[SDU Fragmentation/Packing scheme for 16m]

Document Number: C80216m-09_0017

IEEE 802.16m-08/052 - Call for Comments and Contributions on Project 802.16m SDD
Topic: Fragmentation and packing extended header Section 10.12.2.1

Figure 2: SDU Fragmentation & Packing Sub-headers in IEEE 802.16e-2005

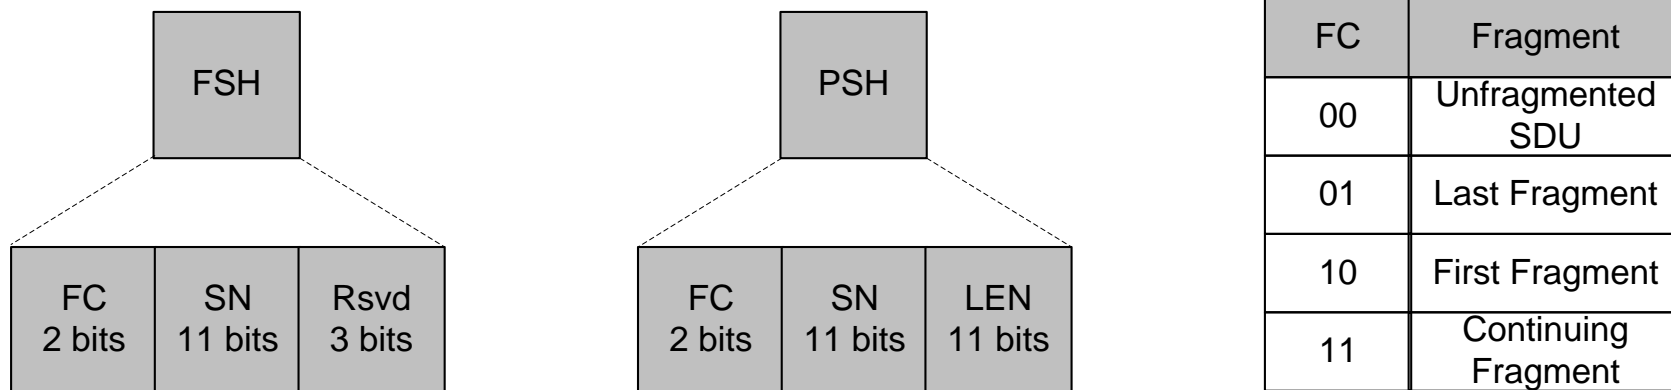
- Packing/Fragmentation overhead
 - Information bits per SDU/SDU fragment packed in MPDU payload
 - Fragmentation Control
 - Not needed per SDU/SDU fragments as SDU/SDU fragments are transmitted in sequence
 - Sequence Number
 - Not needed per SDU/SDU fragments as SDU/SDU fragments are transmitted in sequence
 - Length
 - Length is not needed for Last SDU/SDU fragment packed

Figure 4: Fragmentation and packing extended header

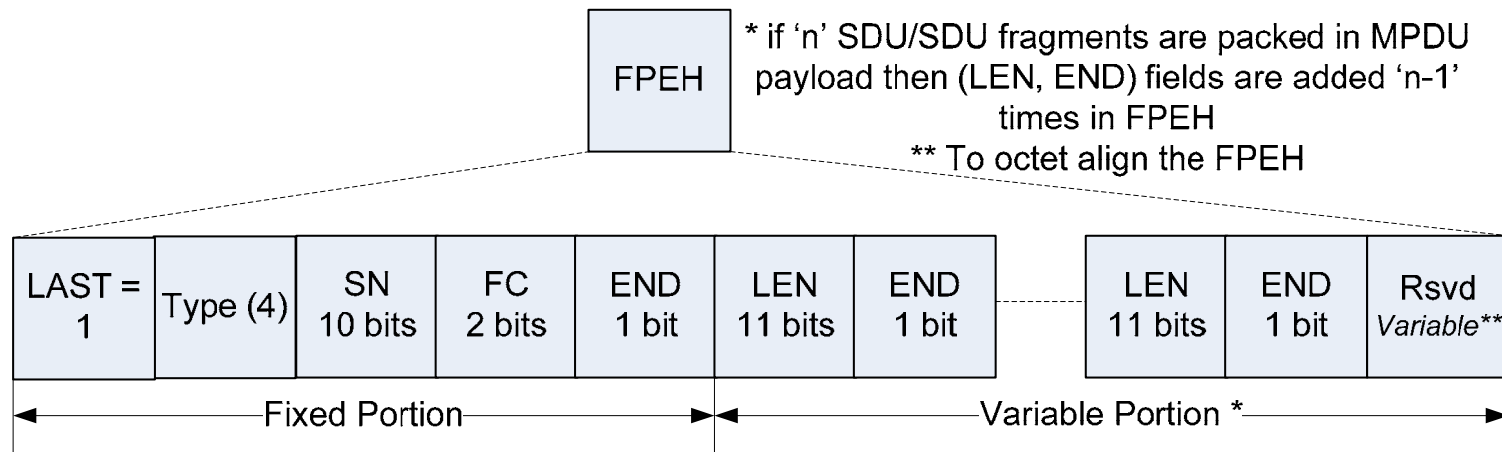
- FPEH is the last extended header present in the MAC PDU
 - LAST = 1 and Type = FPEH
- Sequence Number (SN) is assigned to each Flow payload
- Fragmentation Control bits are added once per Flow payload
 - Redefined to take advantage of in sequence transmission of SDU/SDU fragments
- Length Field is optimised

IEEE 802.16m supports fragmentation of MAC SDU into one or more MAC PDUs and also allows the packing of one or more SDUs/SDU fragments in a single MAC PDU. The fragmentation and packing extended header is shown in figure x. The definition for fragmentation control (FC) bits are given in table y.

- SN : Payload sequence number
- End = 1: Rest bits for byte alignment are reserved.
- End = 0: Length and another End field are followed.
